## Addendum #2 – Elite Hall Addition

Re: Revision to Bid Documents

# ELITE HALL ADDITION 98 WEST MAIN ST HYRUM, UTAH

S001

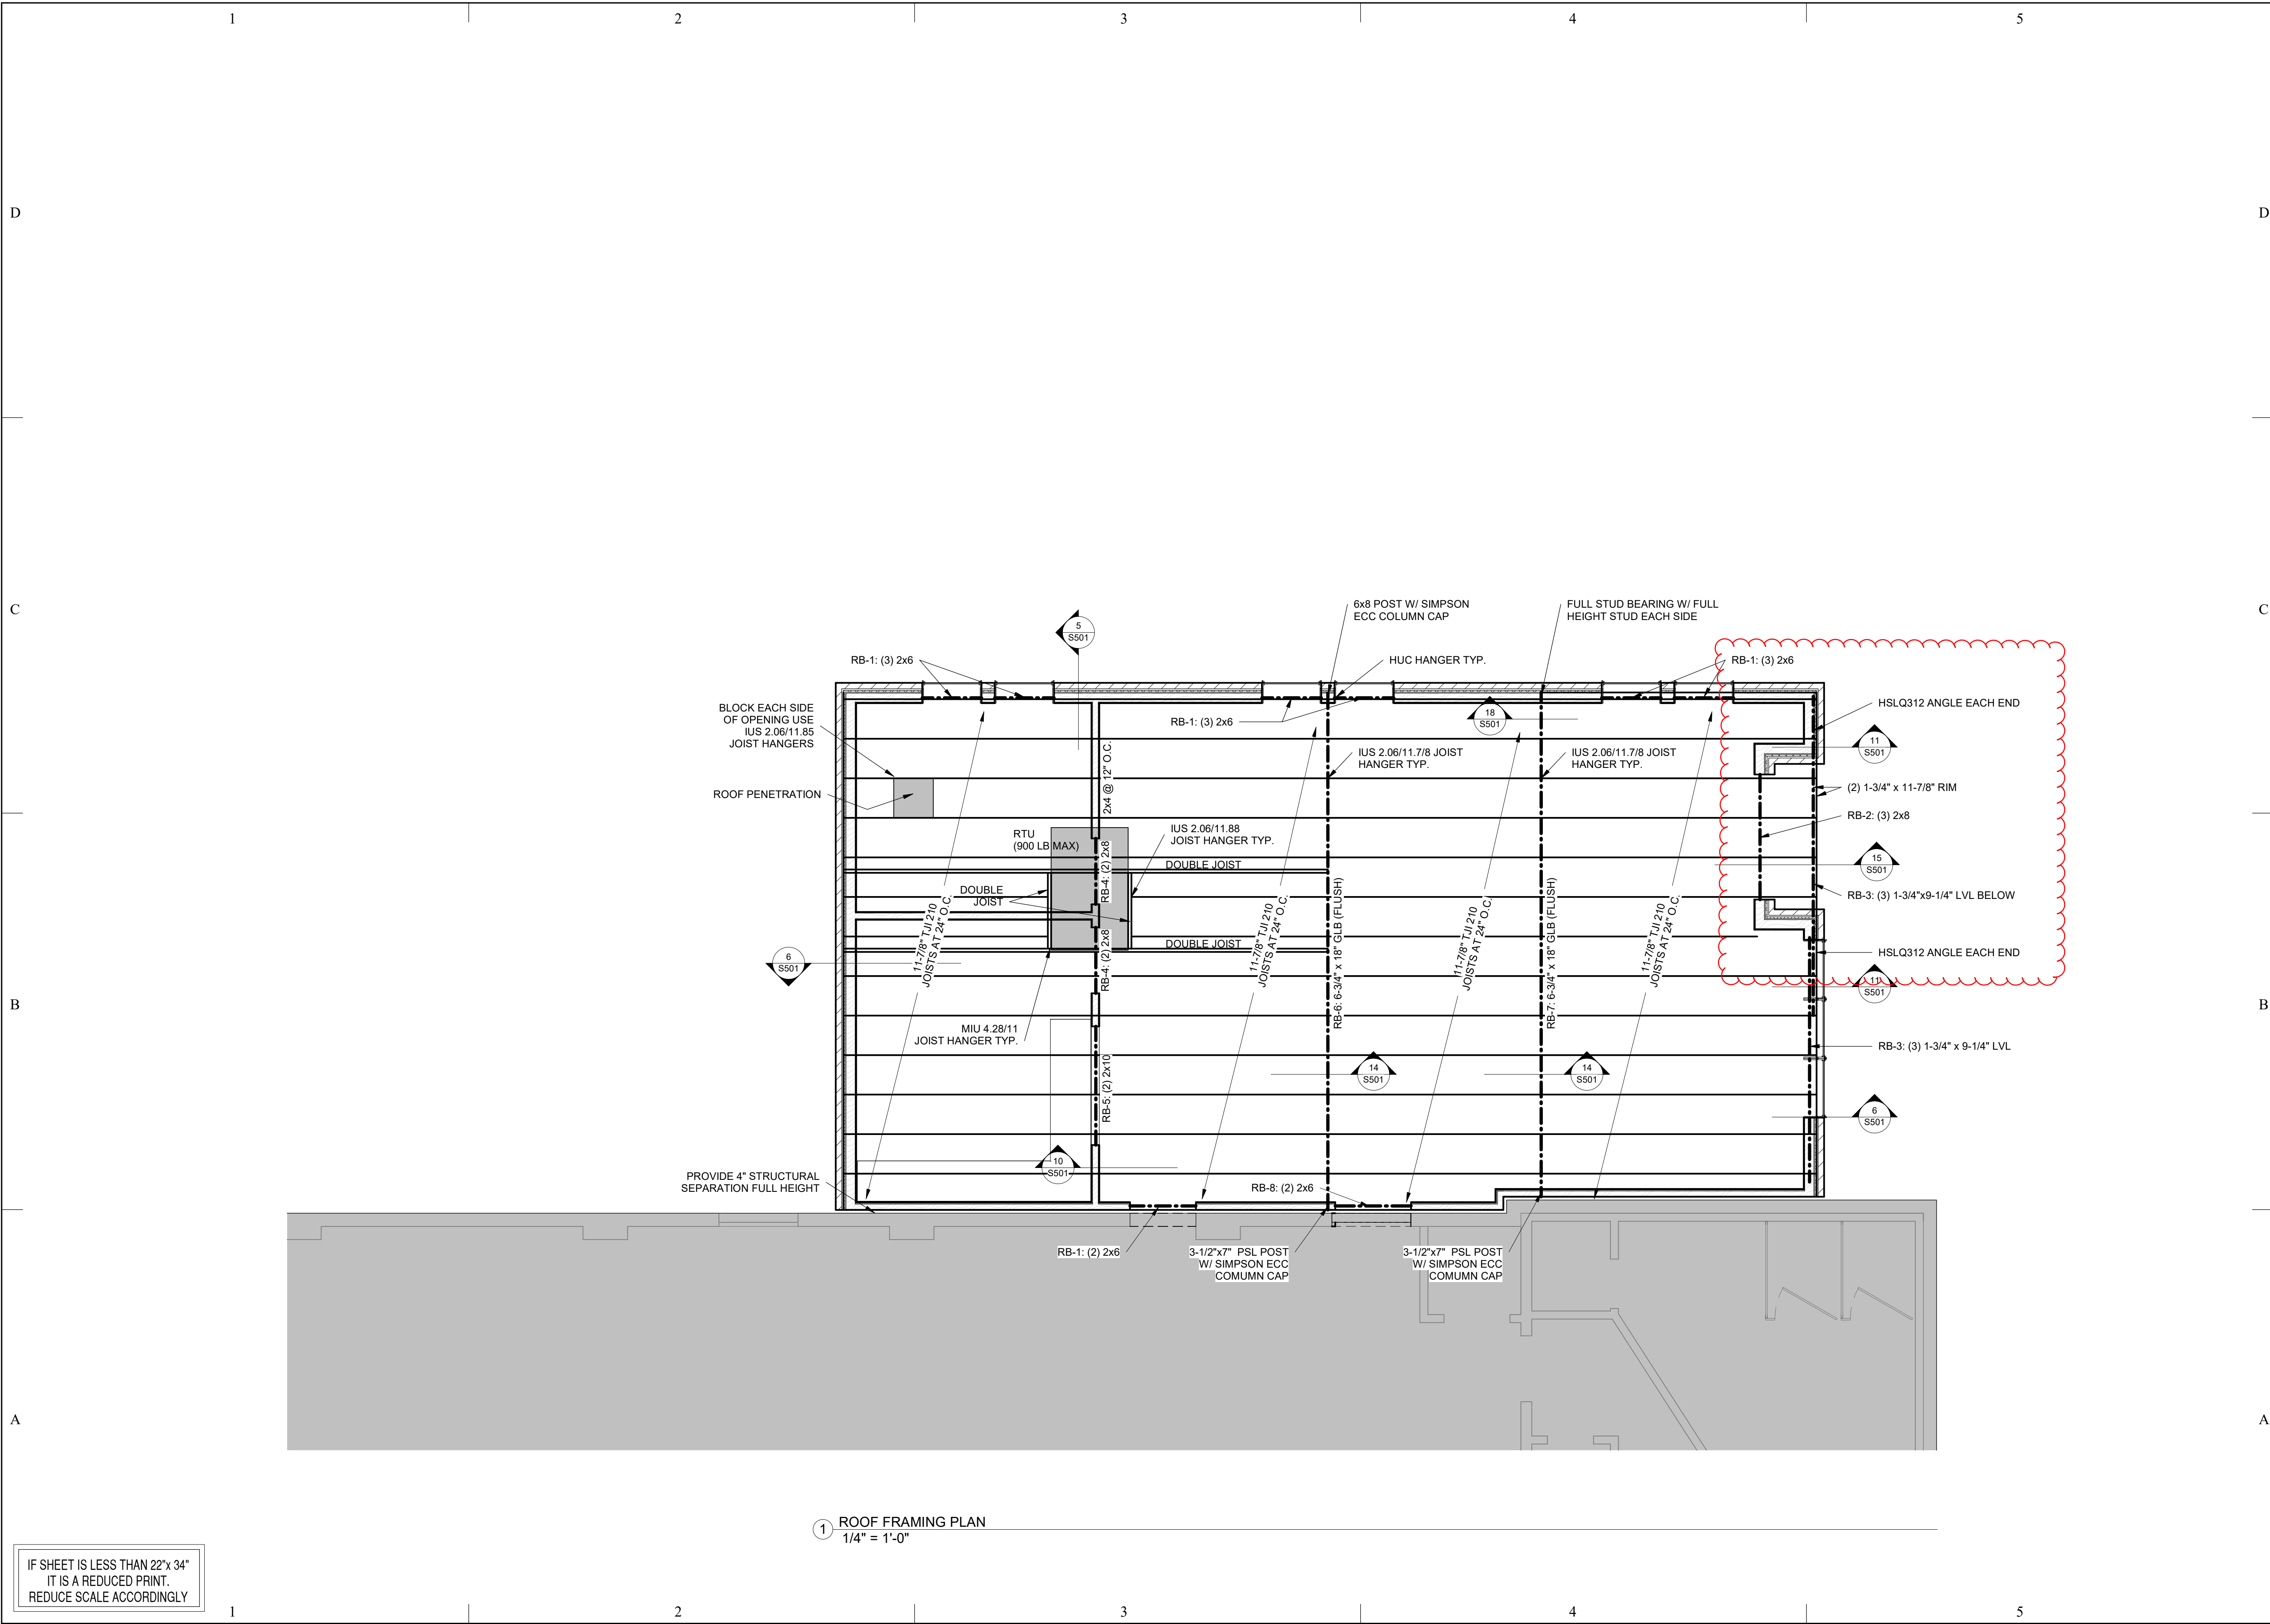
16. The foundation wall schedule on S001 calls for a max height of 4 feet for the FW2, but there aren't any footing steps shown on the plans. That wall would be over the 4-foot max. Please clarify.

Response: The max height was updated to 8'-0" for a concrete wall CW-2.

S103

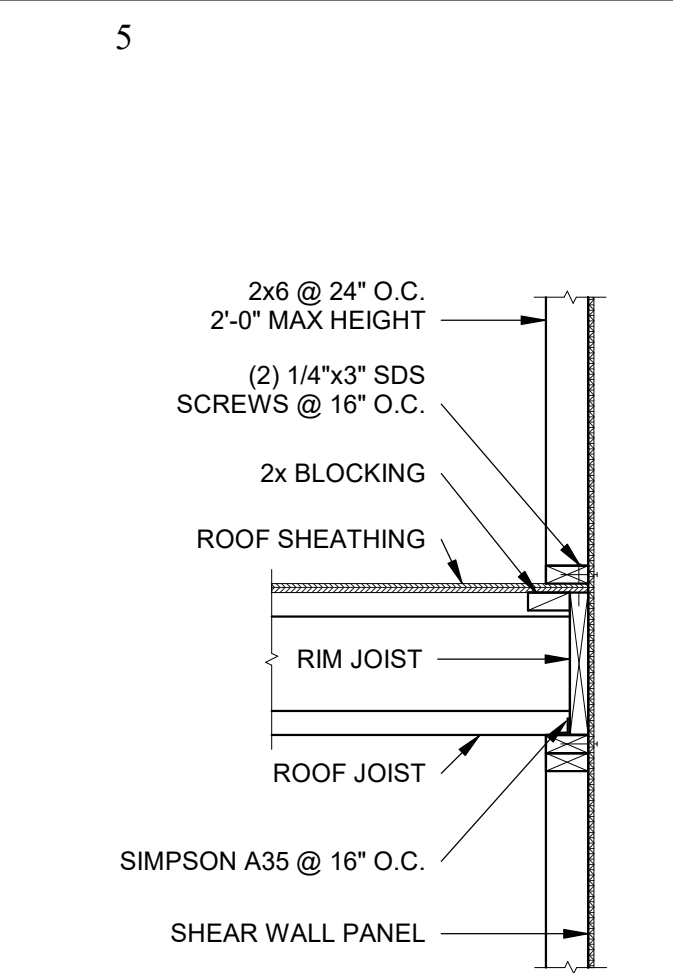
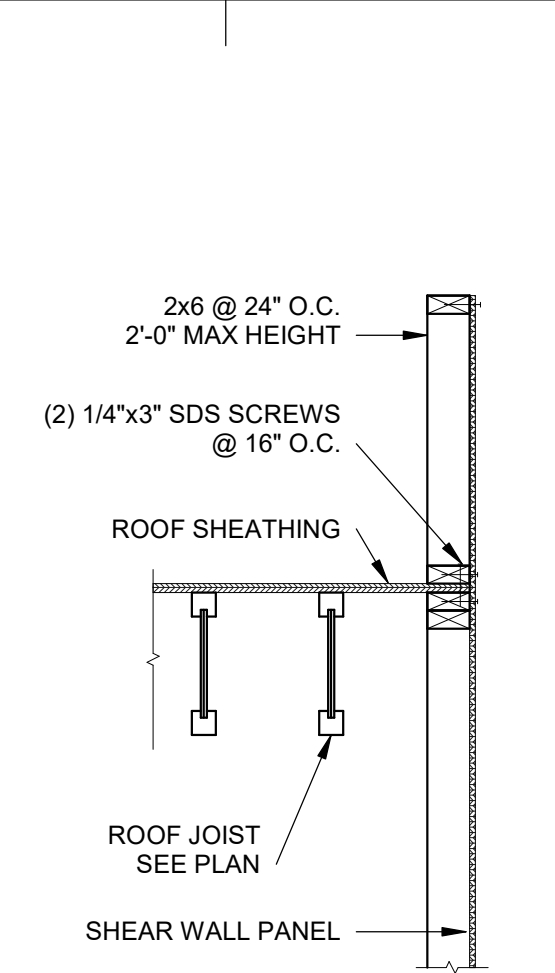
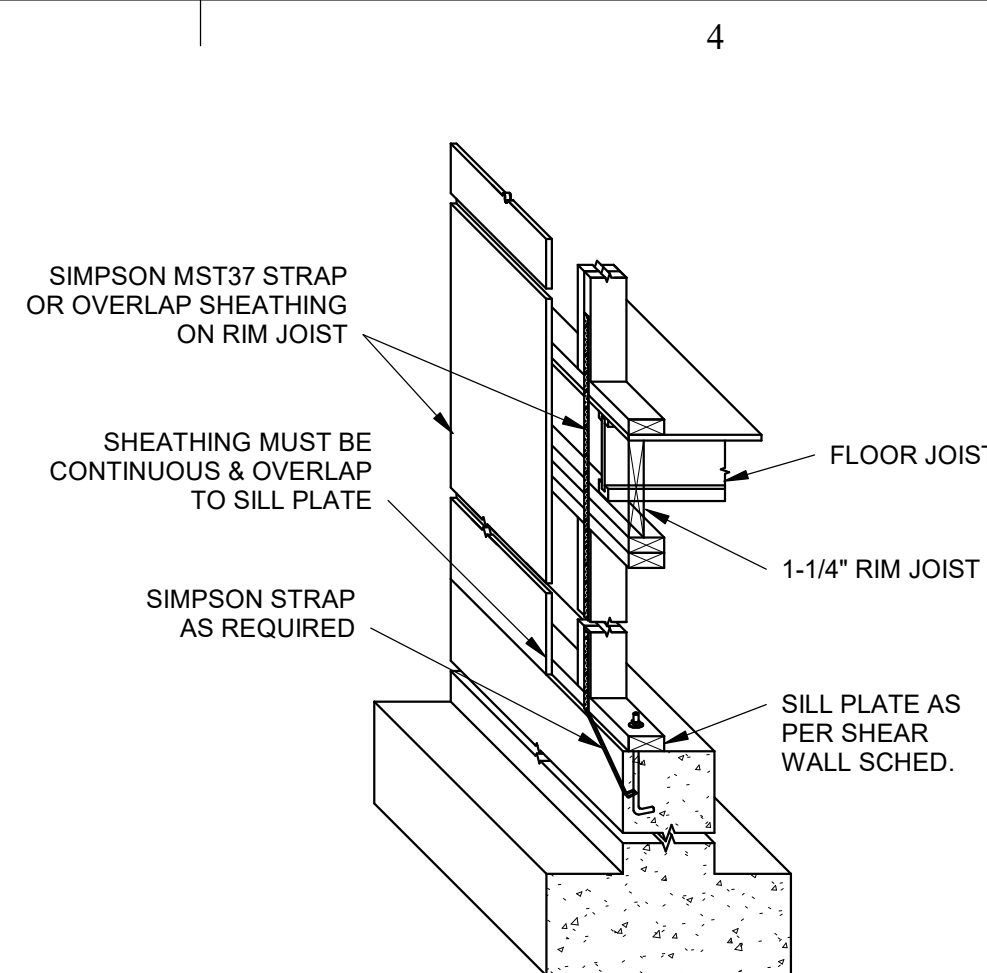
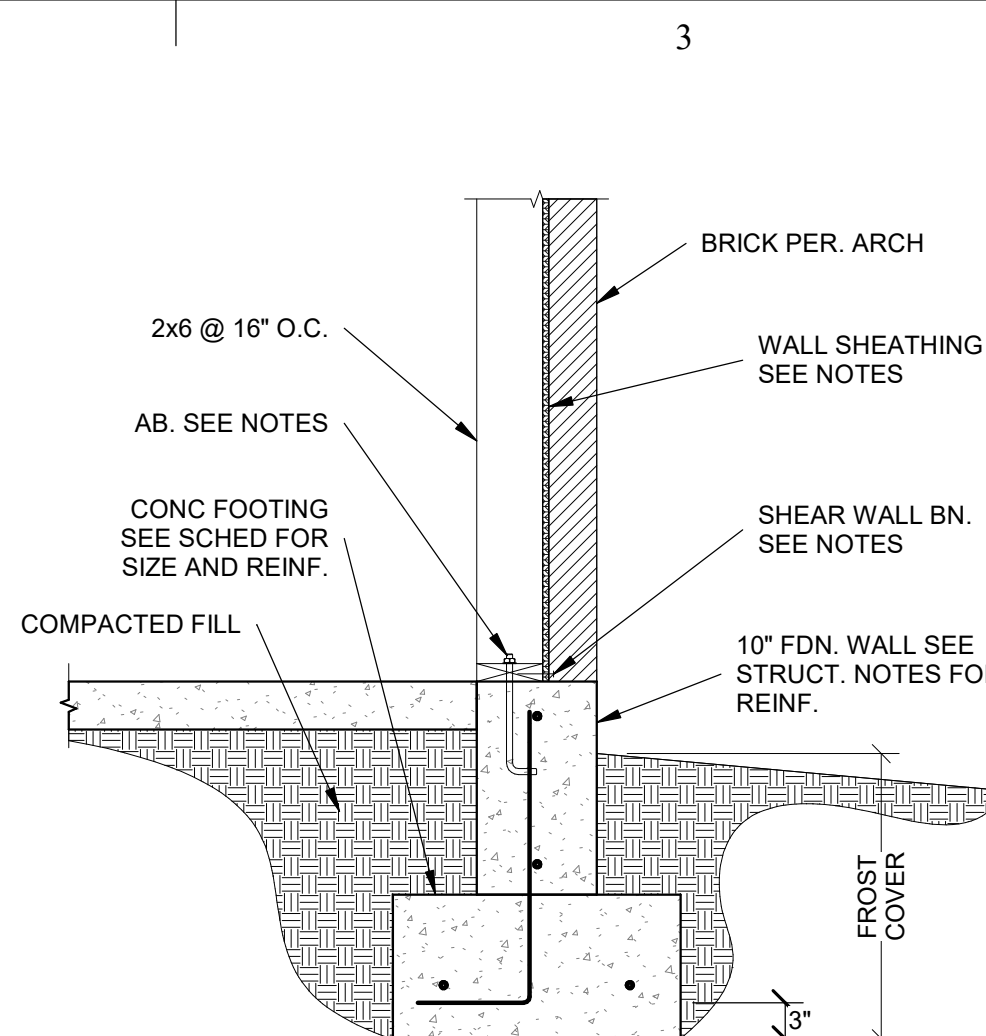
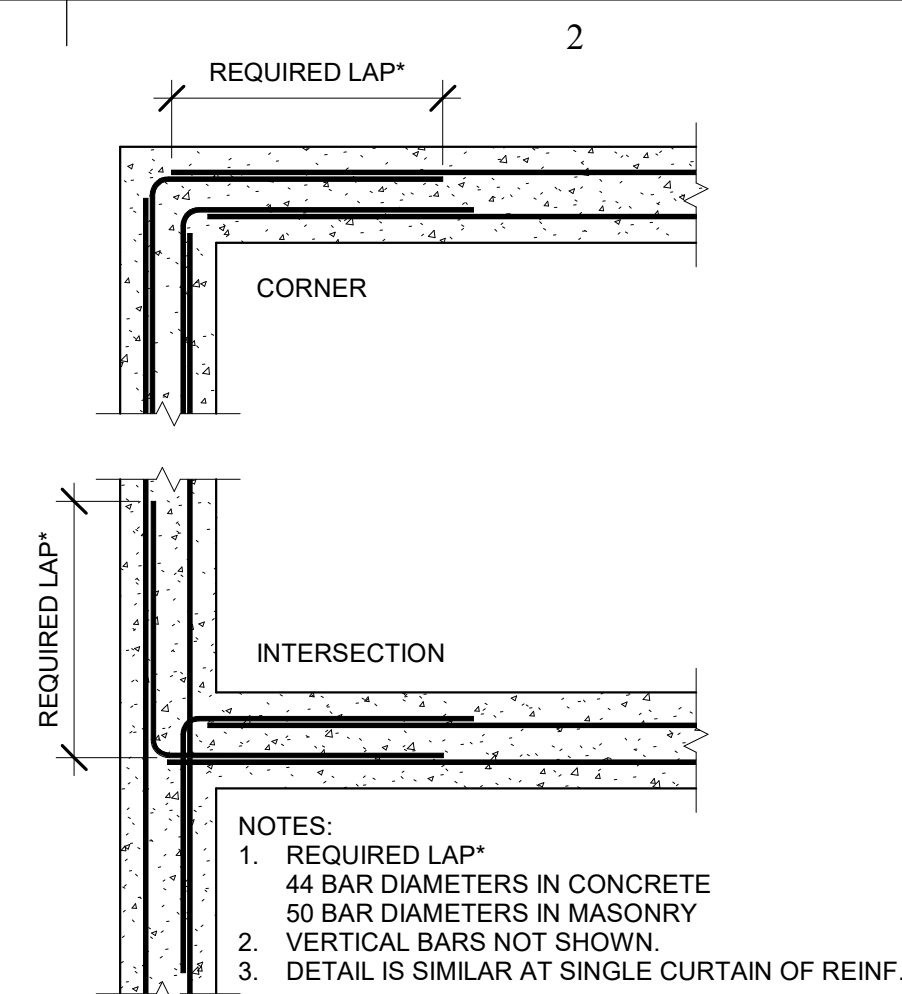
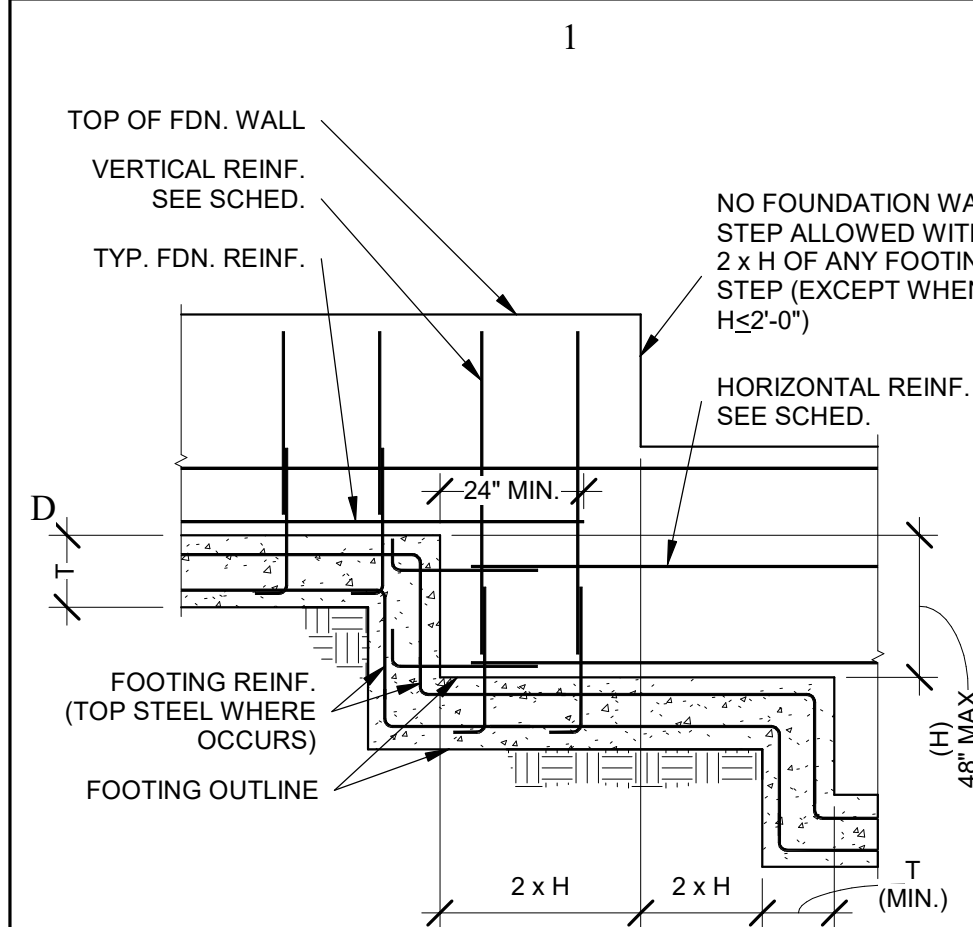
6. There aren't any details specifically calling for wood or metal stud framing for the interior soffit areas. Please clarify if wood is desired or if metal stud framing will work.

Response: Wood framing, see revised A1/A-301, 1/S103, and 15/S501.
